MAVERIK INC. STORE

UTILITY PLANS

MAVERIK INC. STORE
LINCOLN AVE. AND DRANSFELDT RD.
PARKER, CO

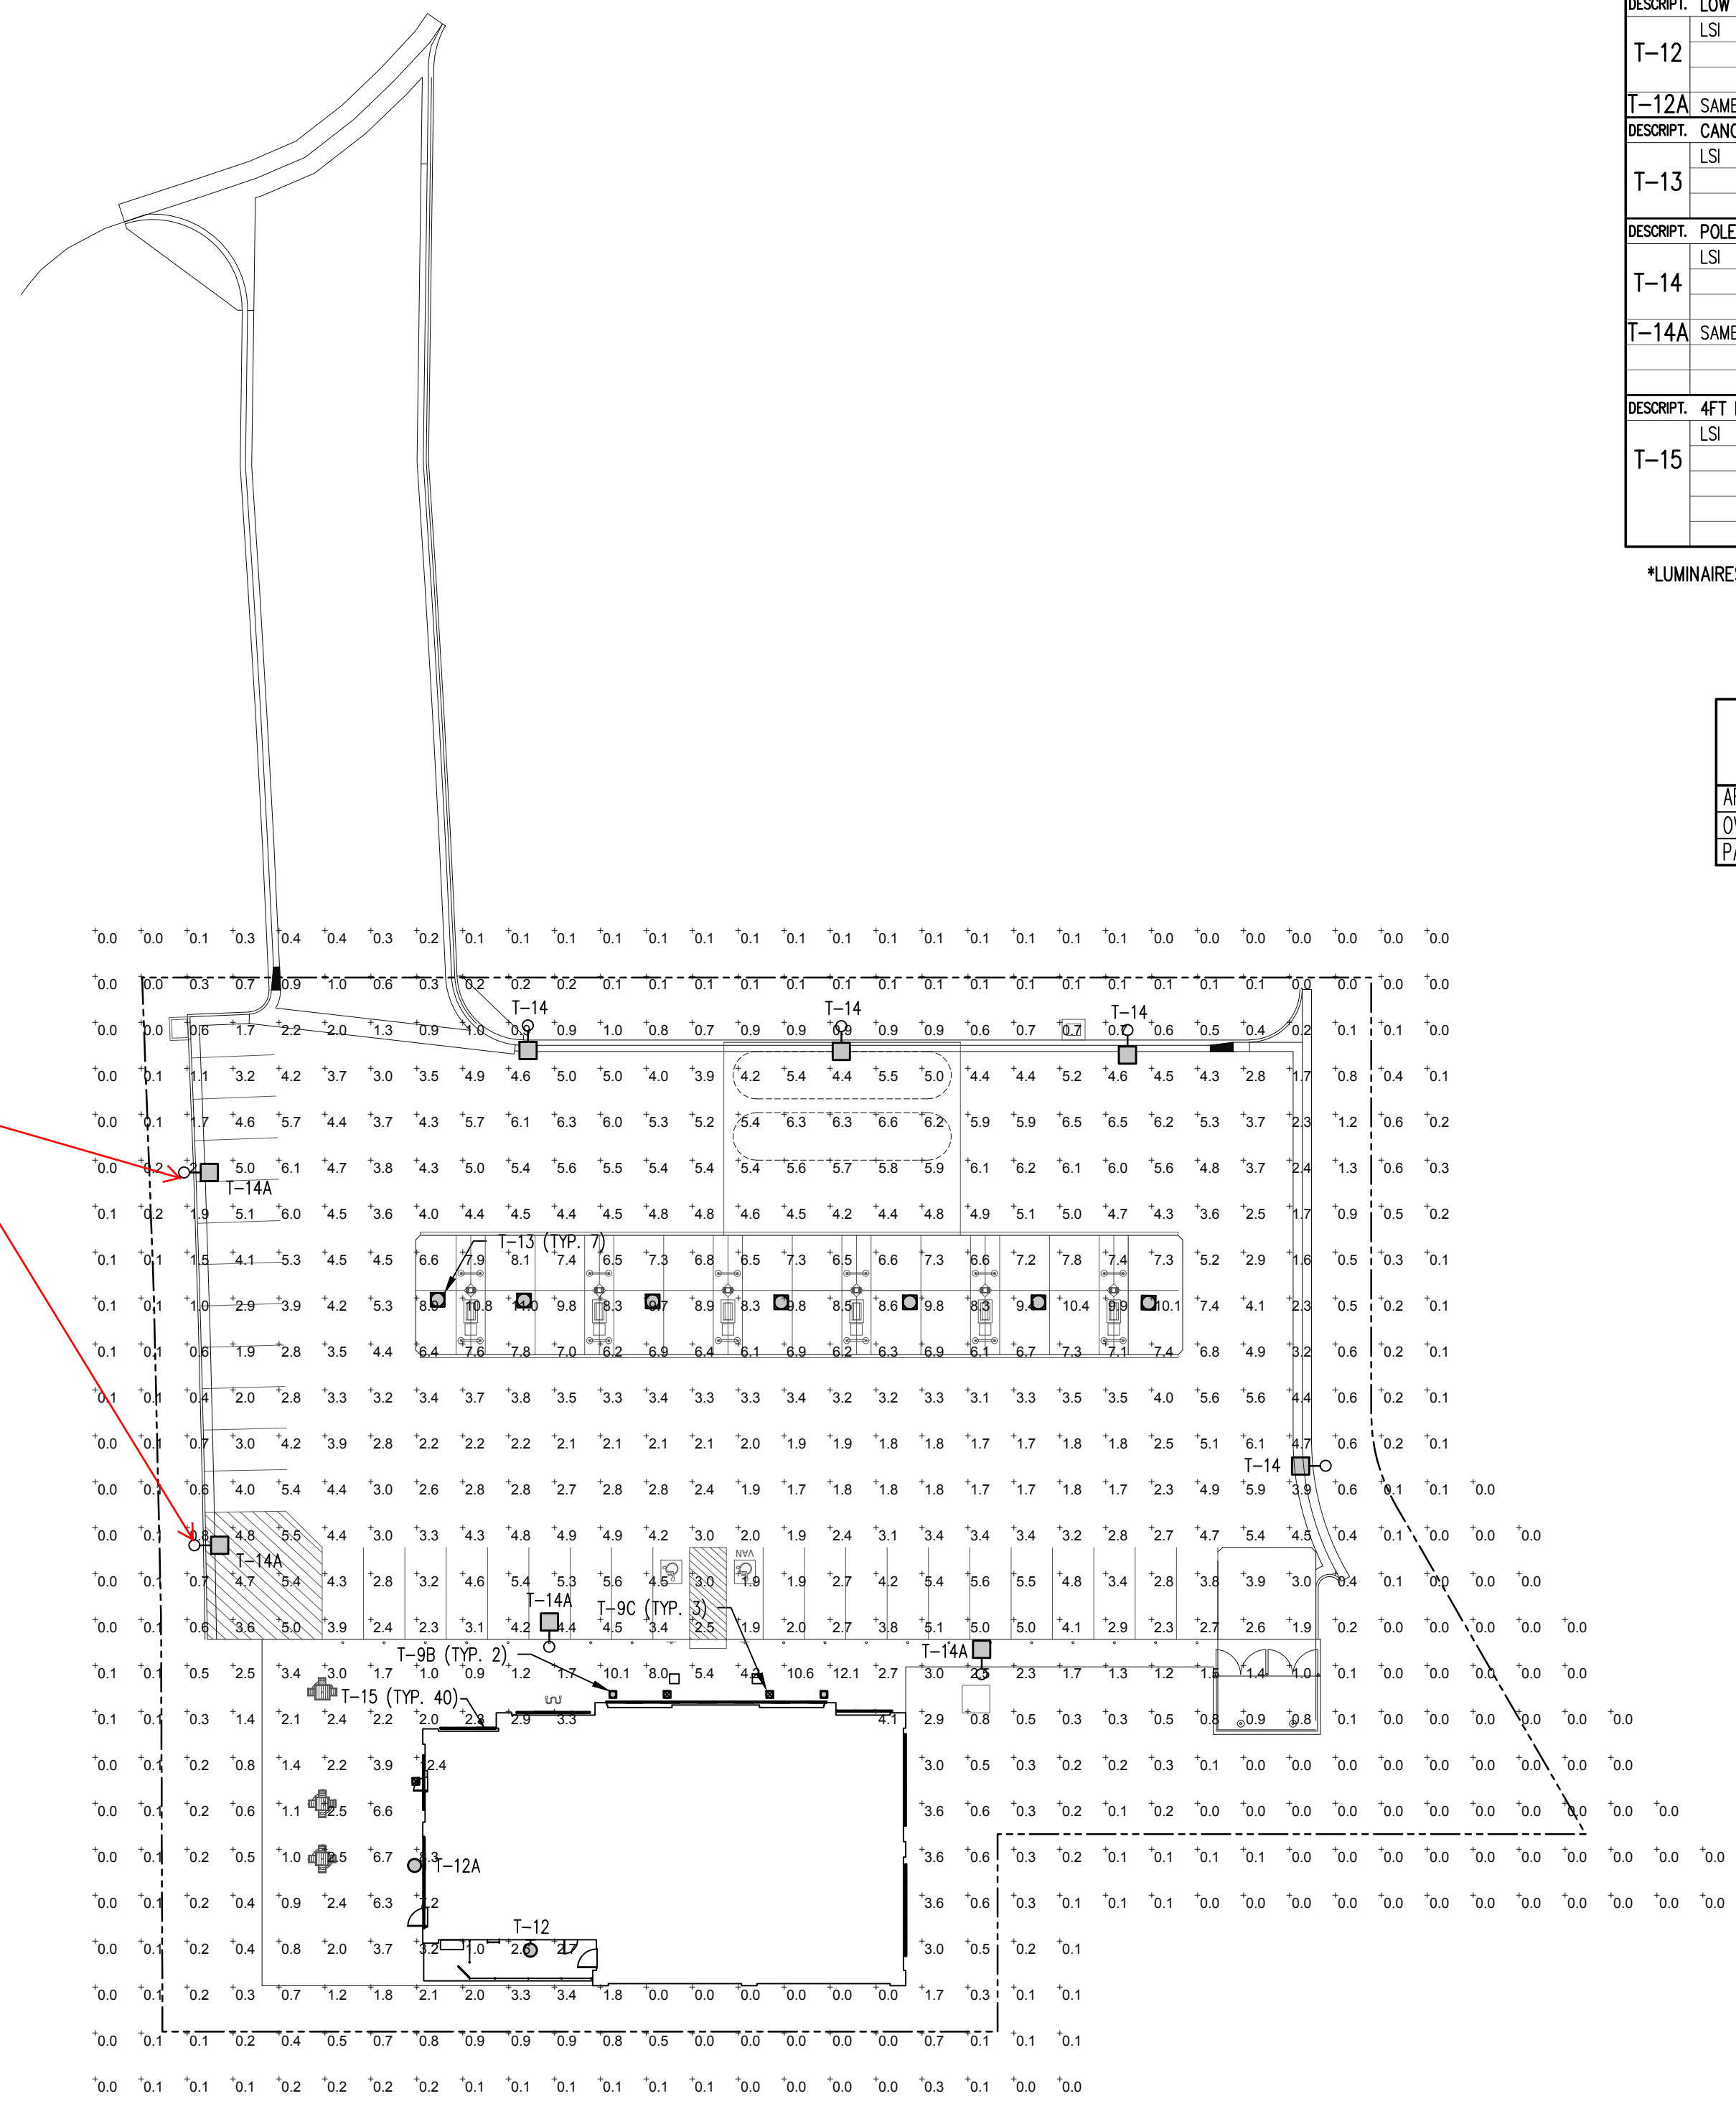
SHOW TRANSFORMER LOCATION AND EUSERC CABINET LOCATION

RETAINING WALL MAY NOT ENCR OACH INTO THE PROPOSED PLATTED 15' UE

DCI RESPONSE: CALLED OUT TRANSFORMER PAD

DCI RESPONSE: THIS WALL IS NOT PART OF THIS PROJECT. SEE MASTER DEVELOPER'S PLANS.

CONSTRUCTION DOCUMENTS

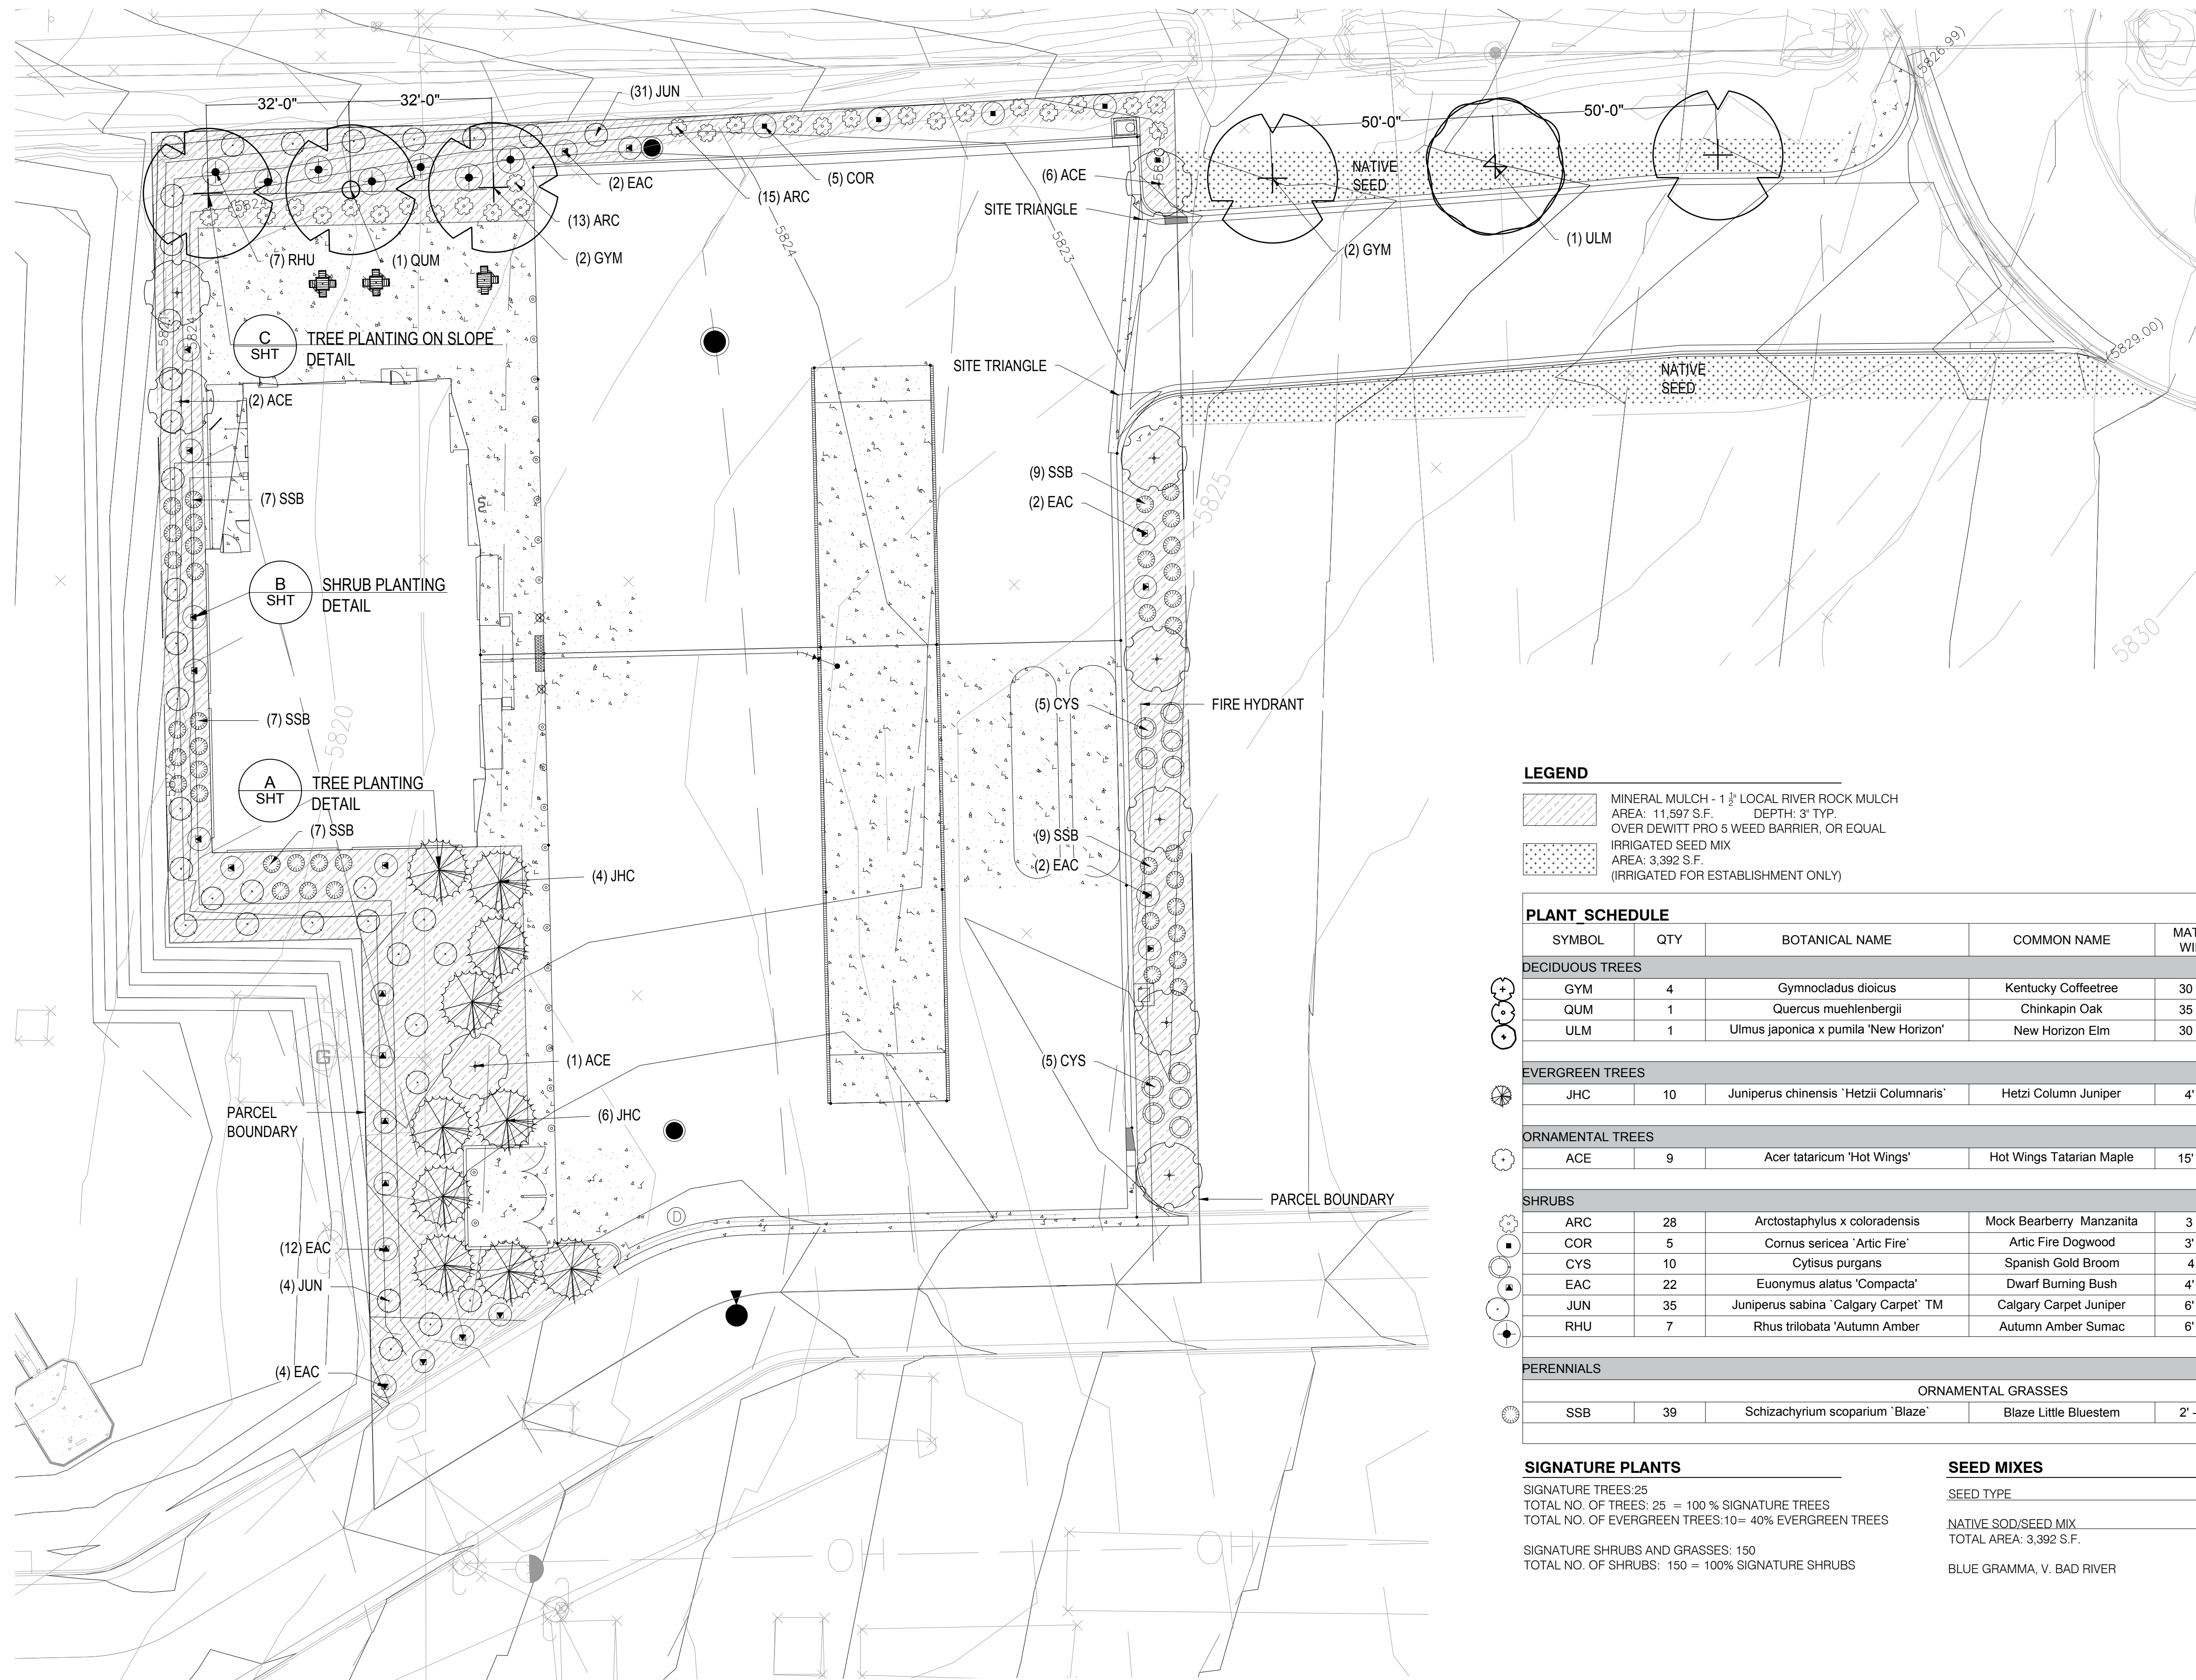
SHOW TRANSFORMER LOCATION AND EUSERC
CABINET LOCATION
